DRAFT

**Specific Site Assessment for
Coal Combustion Waste
Impoundments at Duke Energy
Carolinas Lee Steam Station**

Williamston, South Carolina

LEE STEAM STATION - ASH BASIN
Secondary Dike @ STA 20+80

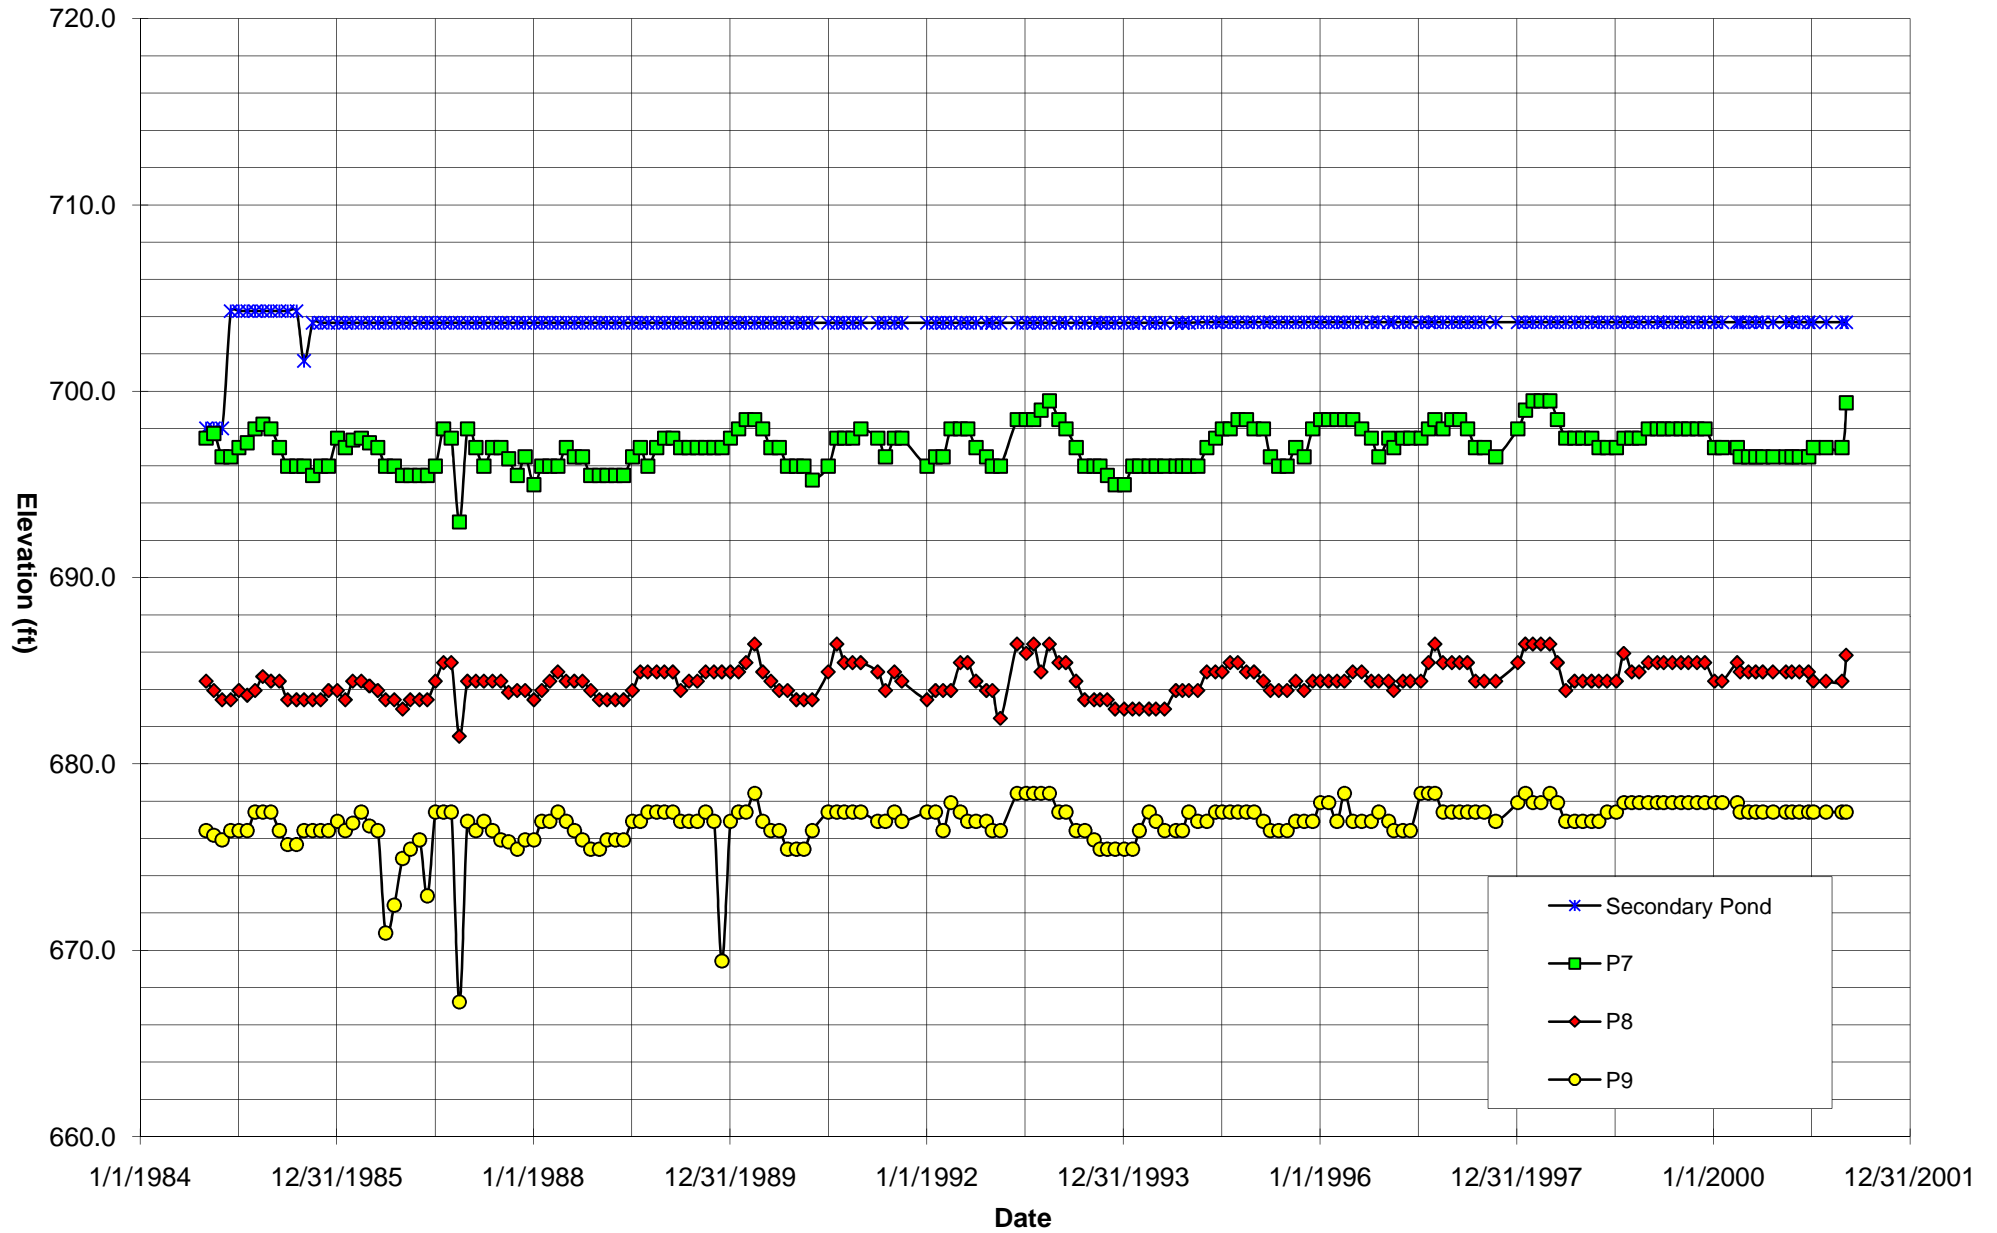
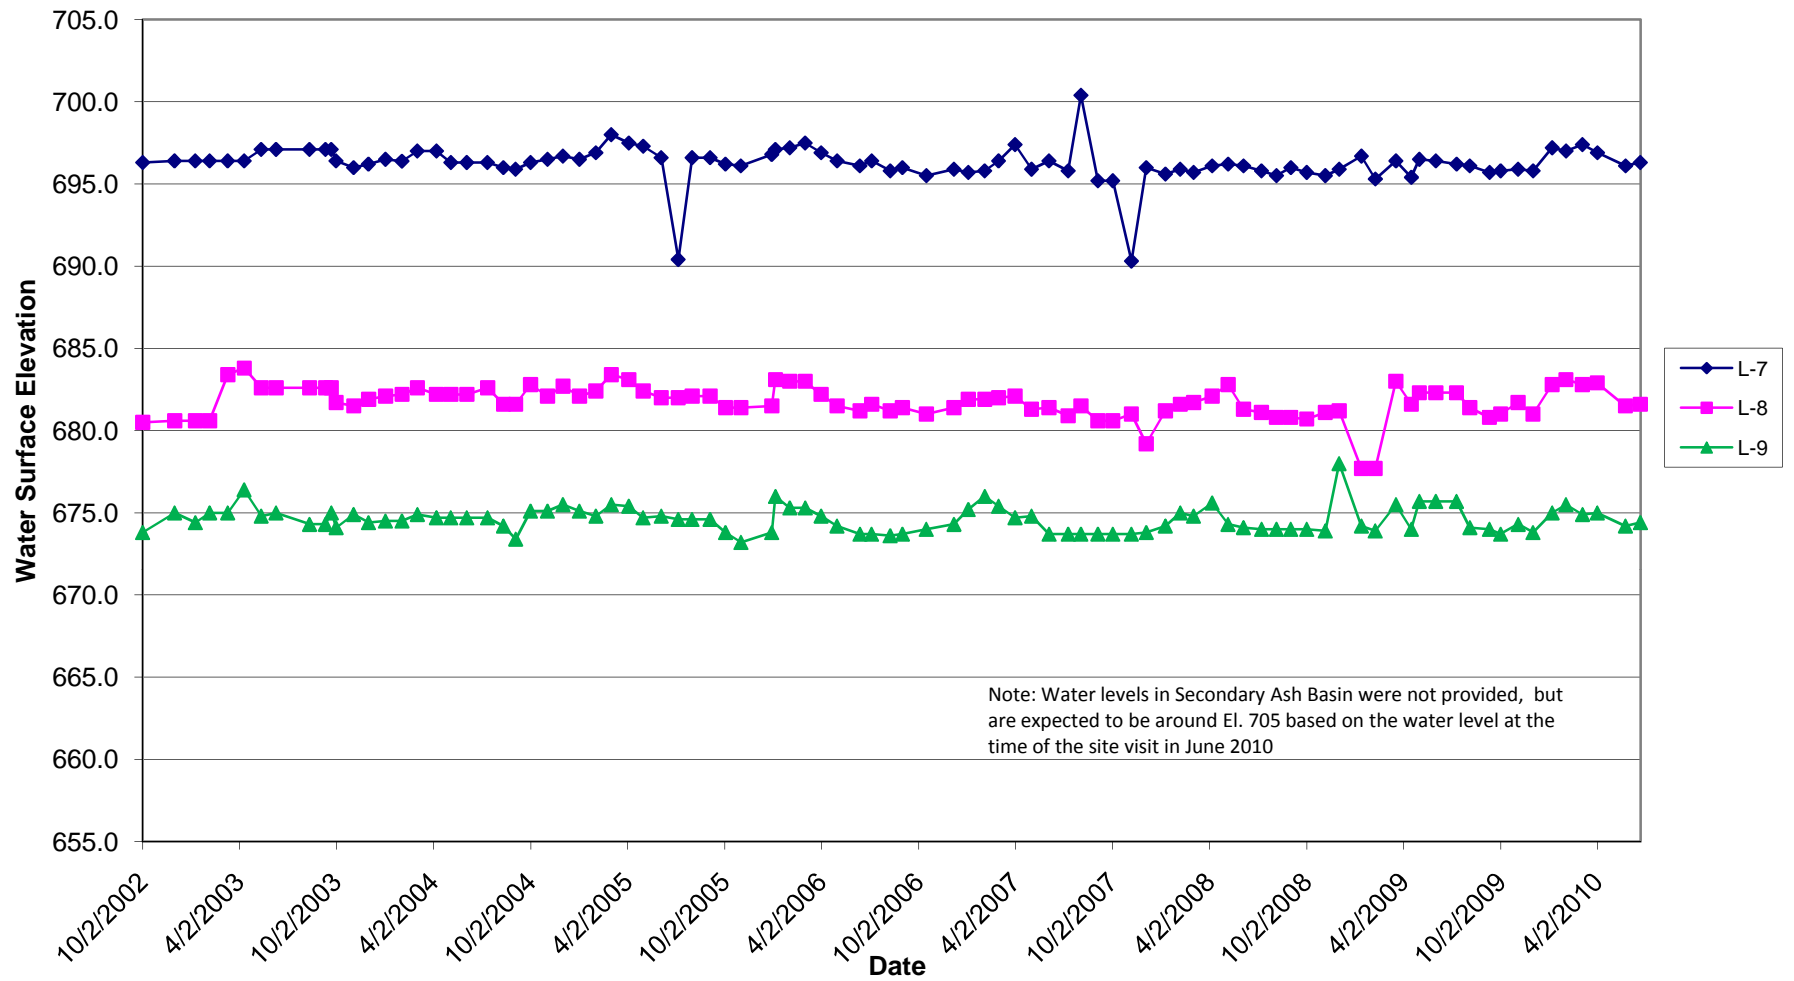
The water levels in piezometers L-7, L-8 and L-9, near the center of the Secondary Ash Basin dam, have remained relatively steady with time. These piezometers generally have fluctuated more than those in the other two cross sections. Typically the water levels in the piezometers fluctuate in parallel with one another and stay within about five feet of an average value with no steady increasing or decreasing trend. The water levels in L-7 and L-8 are similar to the water levels in the corresponding piezometers near the crest and mid-slope of the Primary Active Ash Pond dam. The water level in Piezometer L-9, however, is about ten feet higher than the water levels in the other two piezometers near the dam toe (El. 675 vs. El. 665). The toe drain at this location is located around El. 665 according to design drawings. This elevated water level may indicate that the toe drain is not functioning properly at this location. Piezometer L-9 is also located just west of the seepage area downstream of the right abutment of the Secondary Ash Basin dam, and the elevated water level may be related to the seepage observed at that location.
